ADDENDUM NO. 2

Reference: Student Activity Center Addition to the Stromberg Athletic Complex
Weber State University – Ogden, Utah
DFCM Project No. 12031810

Addendum 002

project:	WSU Stromberg Student Activity Center	**project no:**	12475
date:	2012-10-15	**no. pages:**	75
owner:	DFCM		
contractor:			
bid date:	2012-11-01	**bid time:**	12:00 pm

CD101

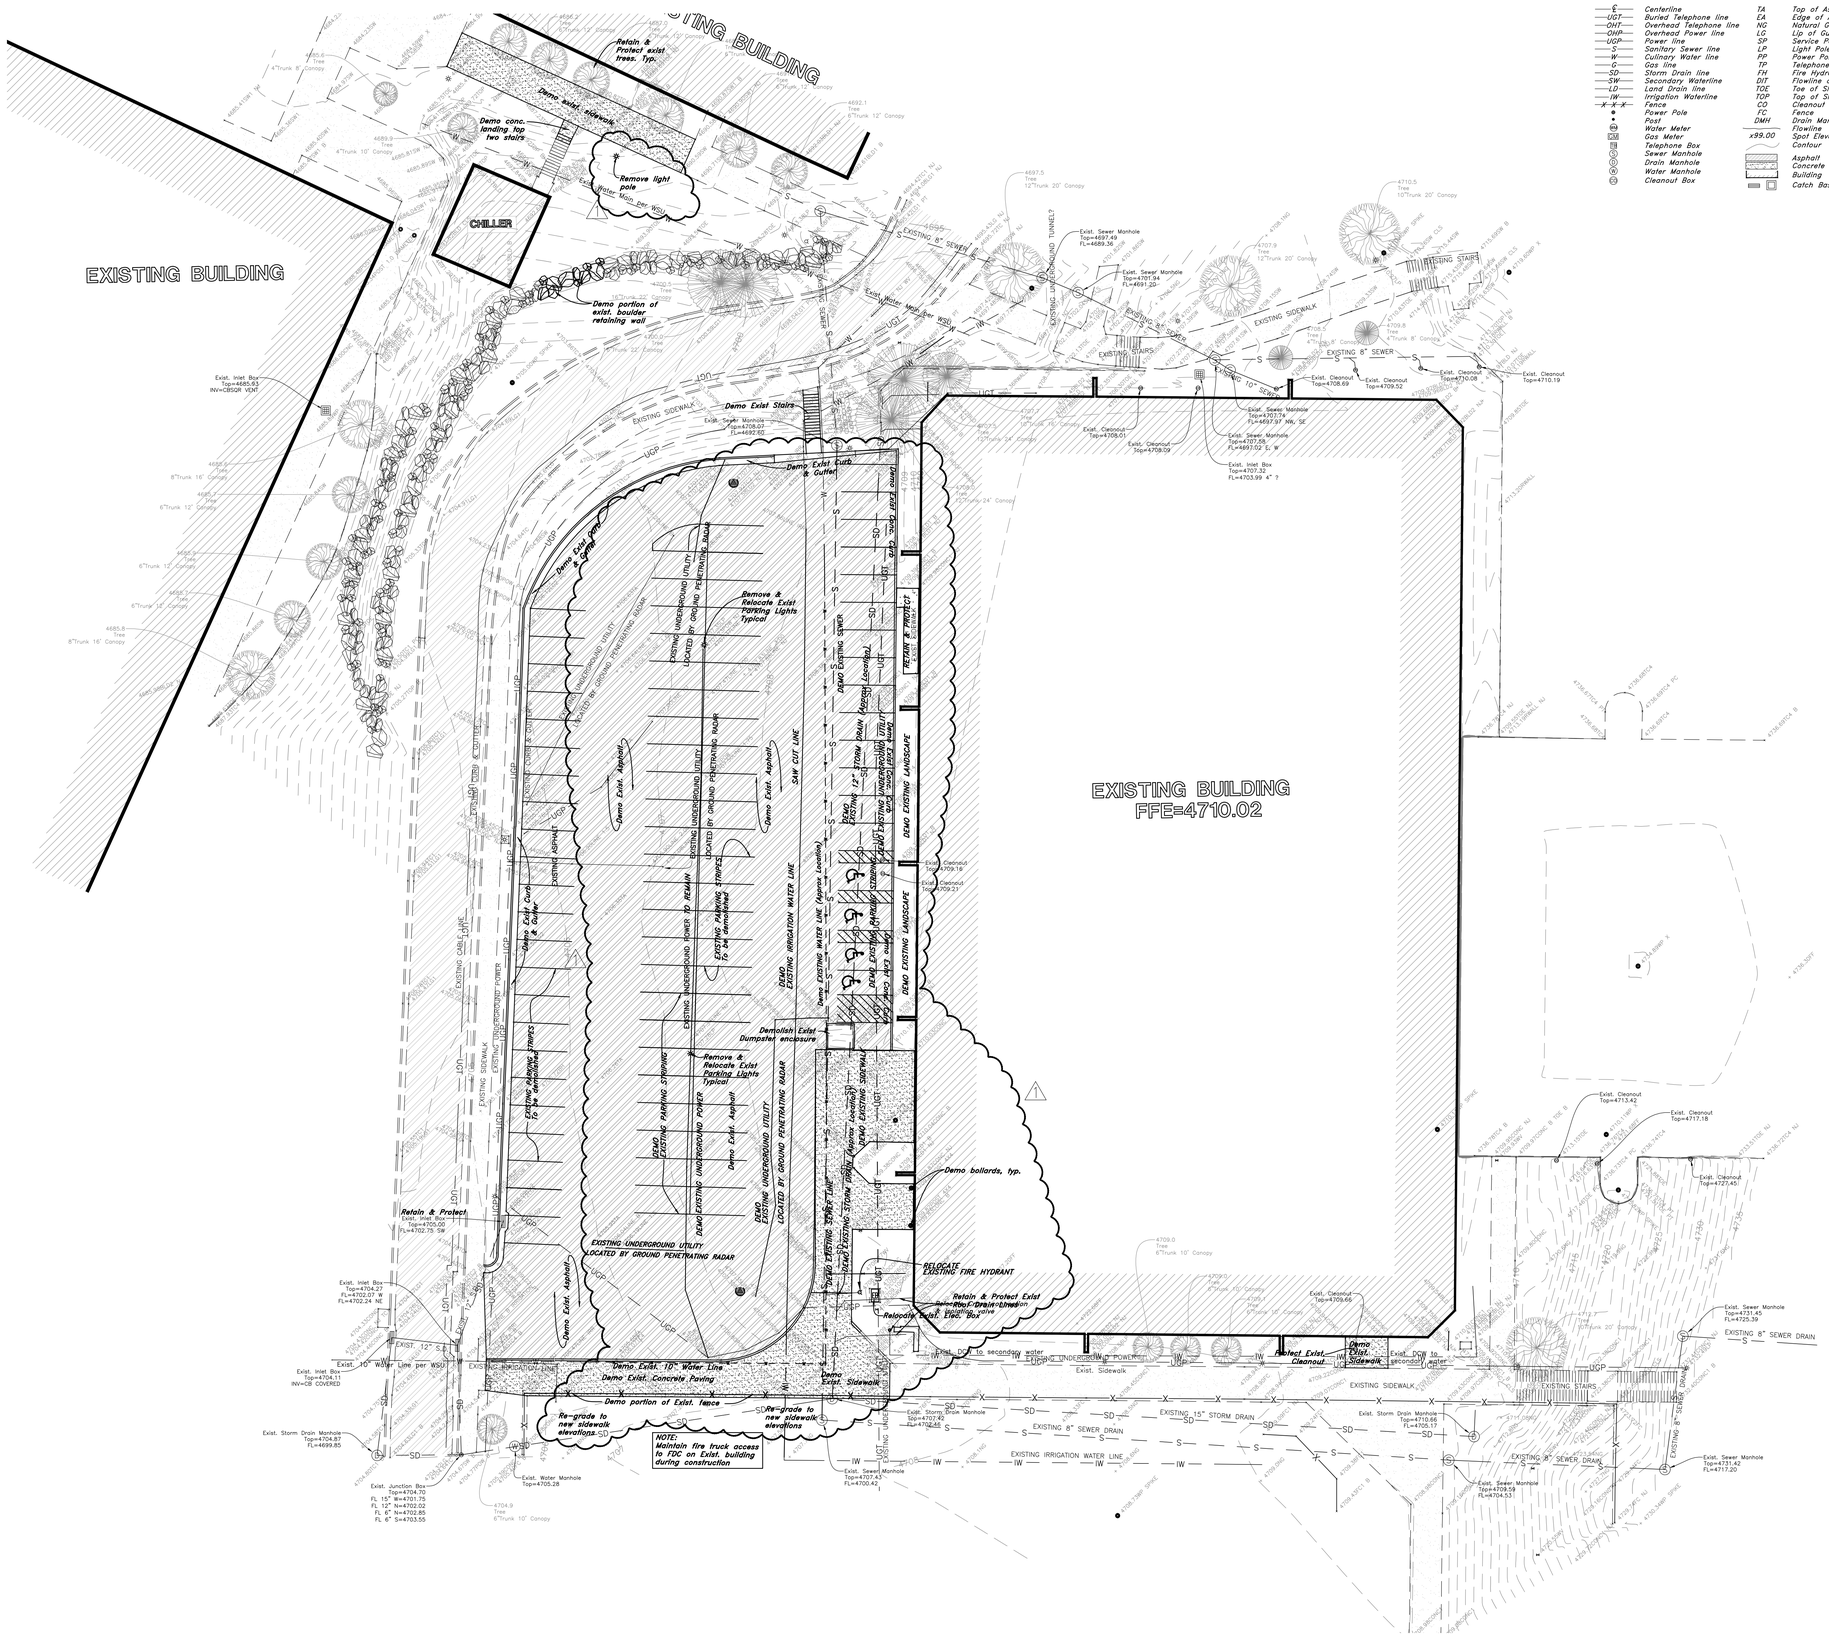
1. CD101:
    1. Added "Note to Contractor"
        1. General Contractor to GPS locate all exposed existing or new utilities before they are buried, and coordinate these locations with WSU.
    2. Corrected note to remove and relocated light pole near new stairs north of access road.
    3. Added note to "Re-grade to new sidewalk elevation" on the south side of the new side walk south of the entrance to the parking lot.

CS101

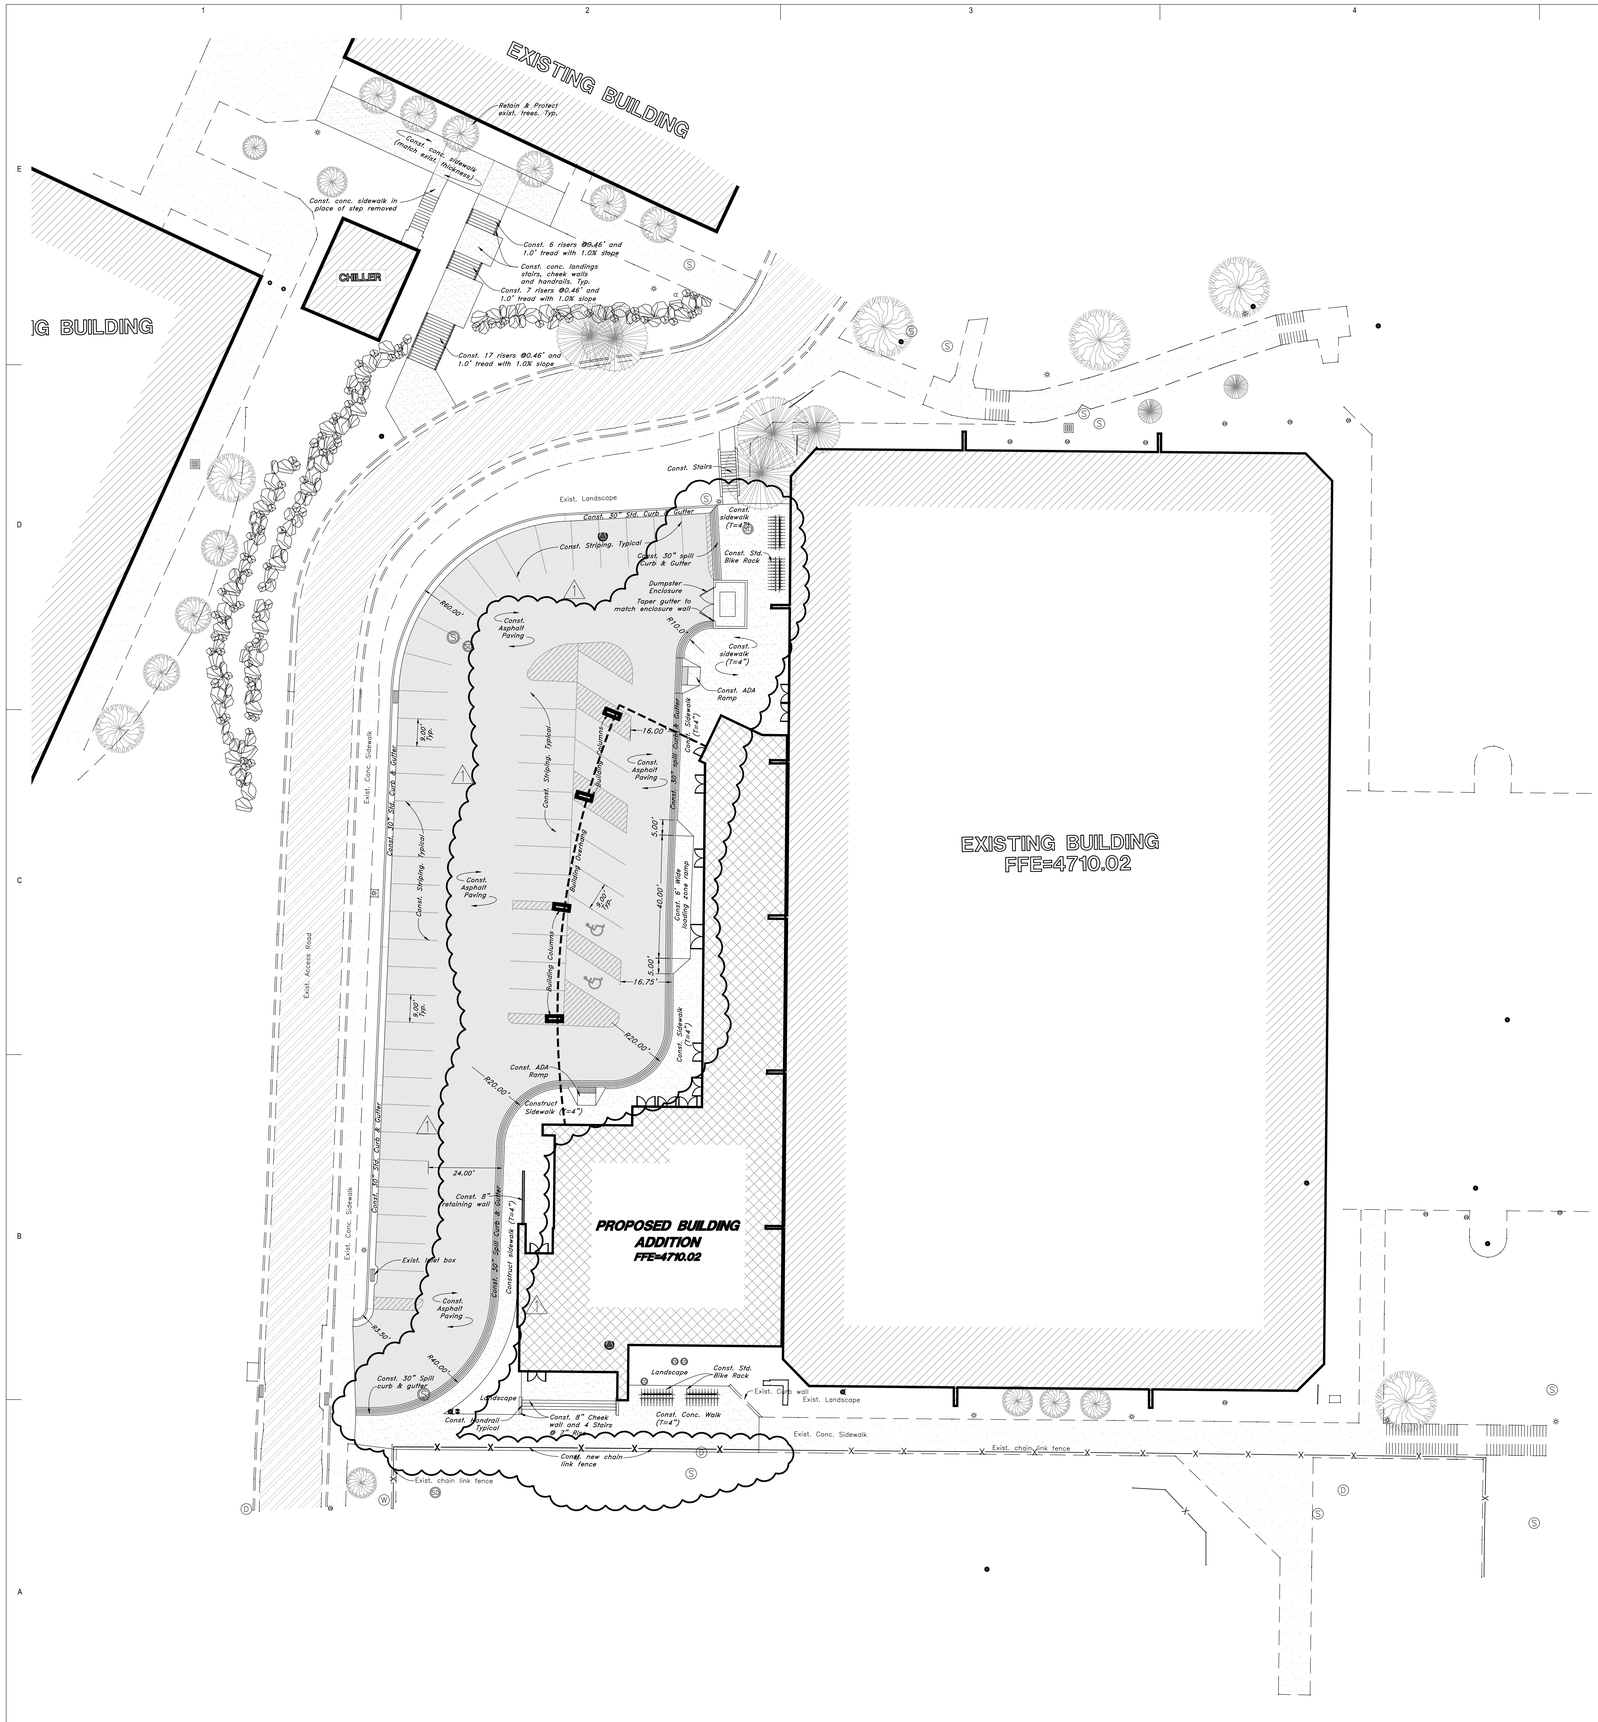
2. CS101
    1. Added one additional parking stall between second story support columns just east of ADA Stalls.
    2. Revised concrete walkway / pad at northeast corner of parking lot, relocated curb and gutter location and added bike racks.
    3. Changed thickened edge walk to "Spill Curb and Gutter" and standard sidewalk along west side of new building addition.
    4. Removed short retaining wall on the south side of the new side walk south of the new addition.

CG101

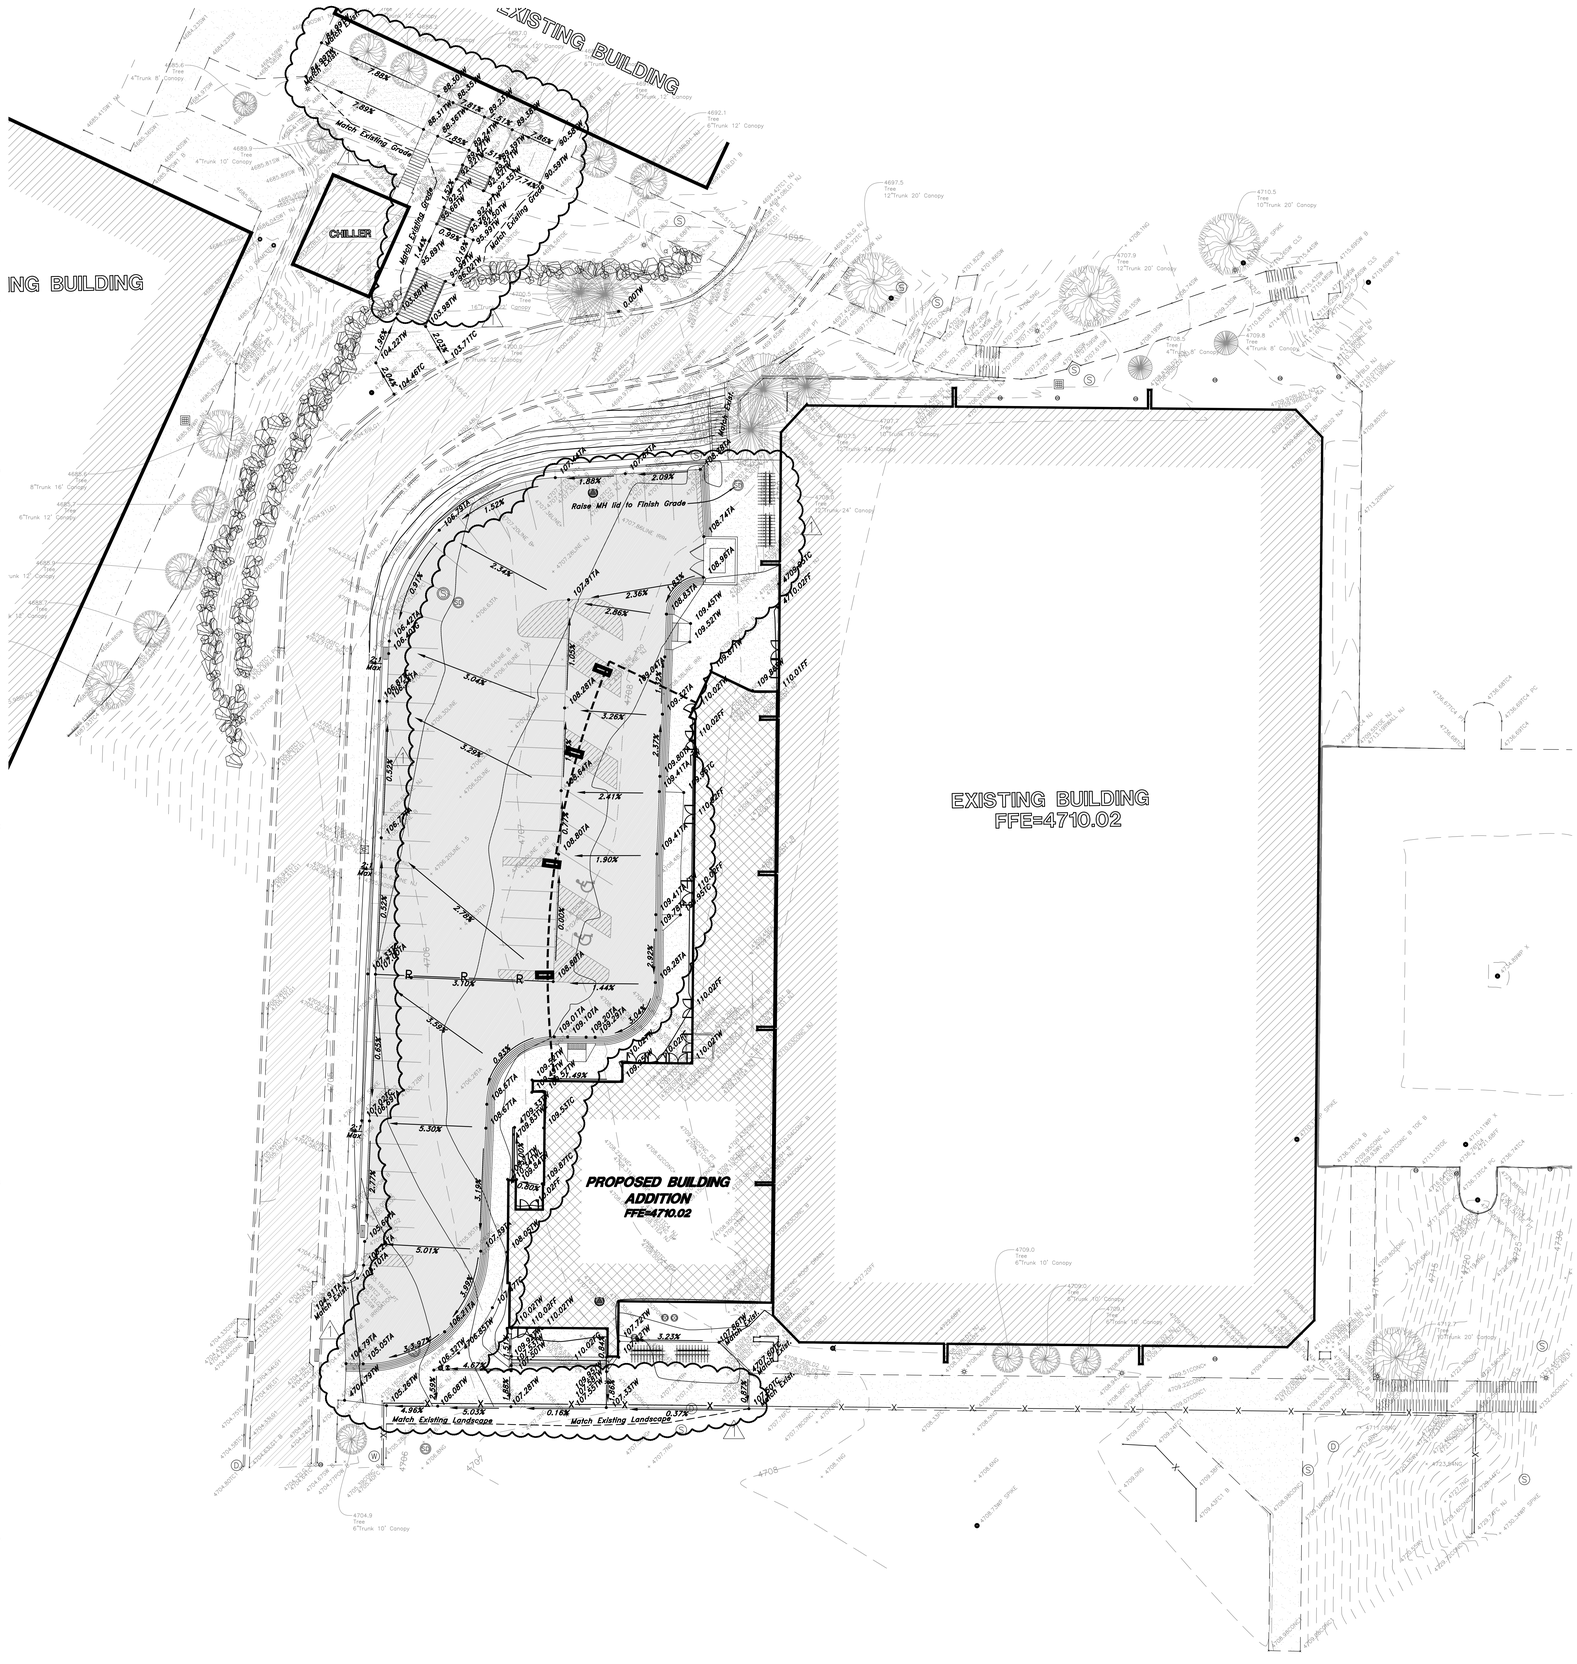
3. CG101
    1. Adjusted grades and slopes in main parking lot area to show new curb and gutter, maintain slopes for handicap parking stalls of less than 2.0% and 2.0% cross slopes on side walks.
    2. Added top of wall elevations at west entrance to western most addition.
    3. Added note along the south side of the new sidewalk south of the new addition to "Match existing landscape grades" about 5 feet south of new sidewalk.

CU101

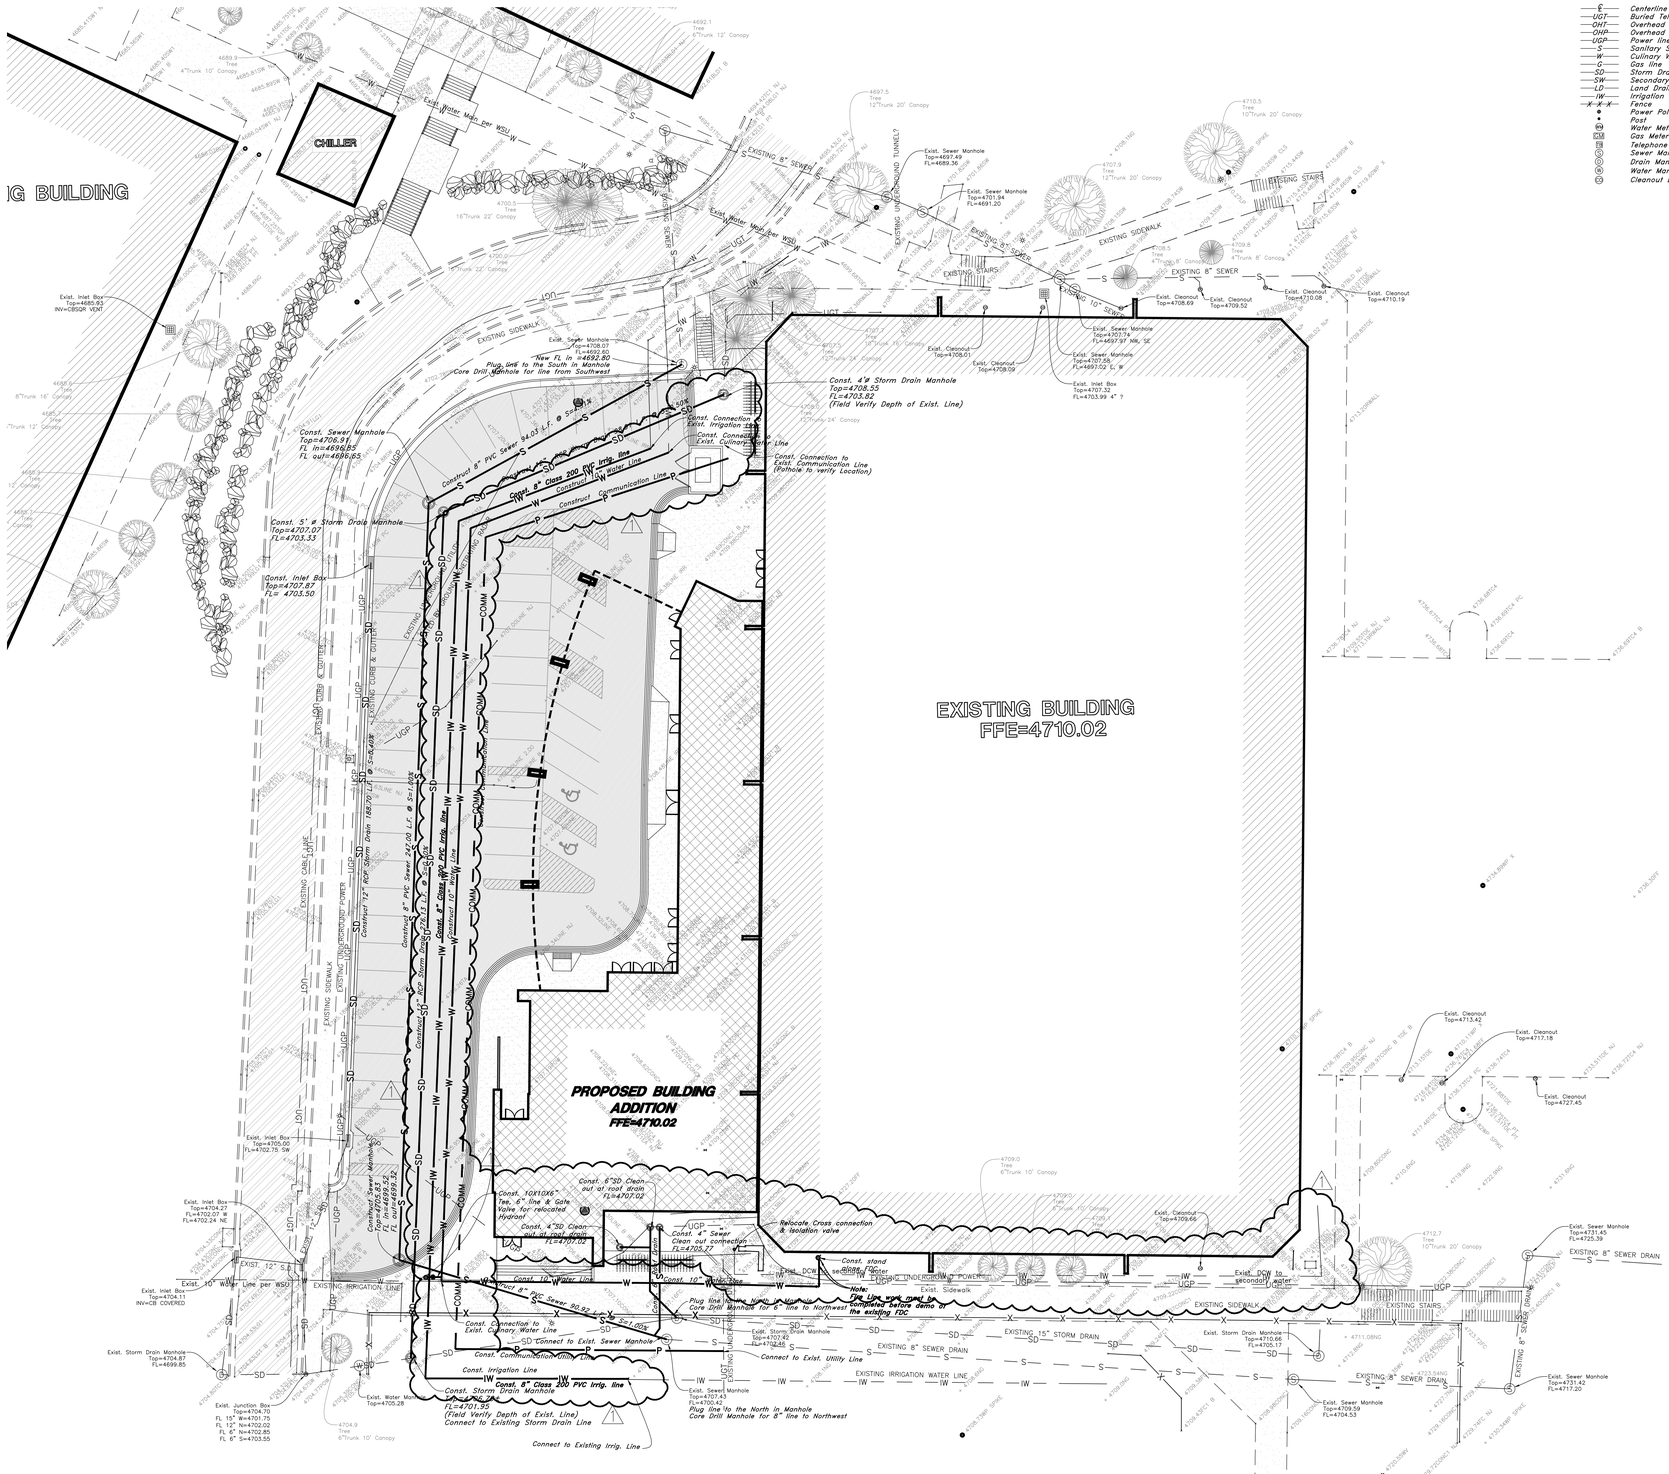
4. CU101:
    1. Increased waterline size from 8" to 10", and changed connections to existing water line from "hot-tap" to a standard connection to be made with water line shut down and drained.
    2. On Irrigation line clarified size and type of pipe " 8" Class 200 PVC Irrigation Line"
    3. Show existing Irrigation line along south edge of existing building with note to "Relocate Cross connection & isolation valve"
    4. Added flow-line elevations to sanitary sewer and roof drain connections at south end of new addition.
